Comment-Response Document 2014-02

Specific risk and standardised criteria for conducting aeroplane-level safety assessments of critical systems

CRD to NPA 2014-02 — RMT.0049 (25.029)

Figure A5-1: Fault Tree

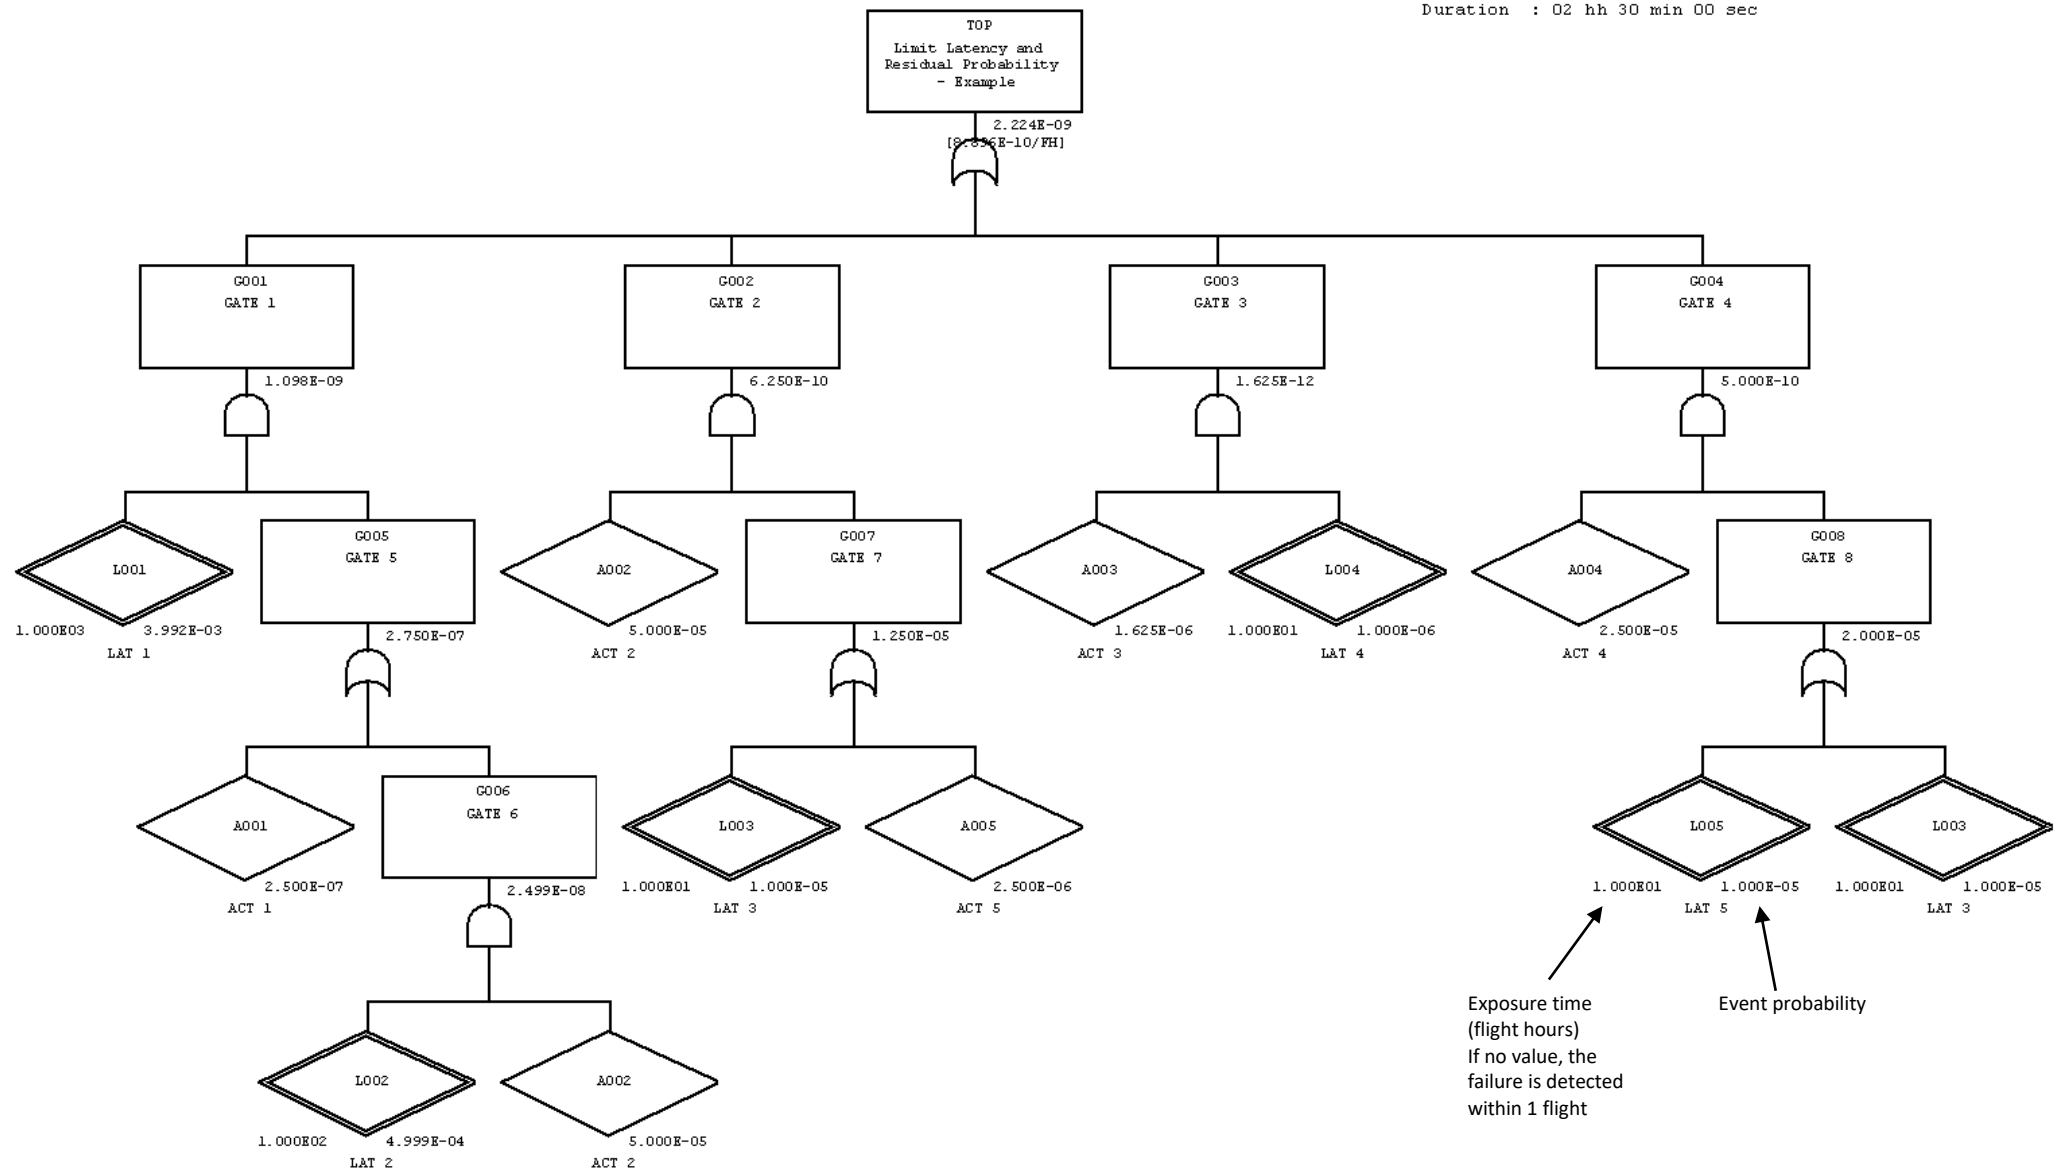
comment	5	comment by: <i>Duane Kritzinger</i>
	Page 50 of 60: Table A5-2: I am not sure I follow the logic in #2 and #3 . More explanation is needed.	
response	Accepted. CS 25.1309(b)(5)(ii) and the column ‘CS 25.1309(b)(5) Applicability / Compliance’ for items #2 and #3 have been clarified.	
comment	79	comment by: <i>Thales Avionics- JD Chauvet</i>
	Table A5-2 and Figure A5-1: The accuracy of provided numbers (time and probability) is ambitious but unrealistic ==> remove the decimal of the numbers	
response	Not accepted. While EASA agrees with the comment, the sole purpose of Figure A5-1 and Table A5-2 is to illustrate the applicability and compliance criteria of CS 25.1309(b)(5).

Change " $P[\text{LAT } i] \sim \text{FR} * T$ " by " $P[\text{LAT } i] \sim \text{FR} * T/2$ ". Adapt Table A5-2 and Figure A5-1 consequently.

JUSTIFICATION: The 1.0 hour flight used in the example in Figure A5-1 and Table A5-2 results in the following issues:

The purpose of Figure A5-1 and Table A5-2 is to illustrate in a simpler manner the applicability and compliance criteria of CS 25.1309(b)(5).
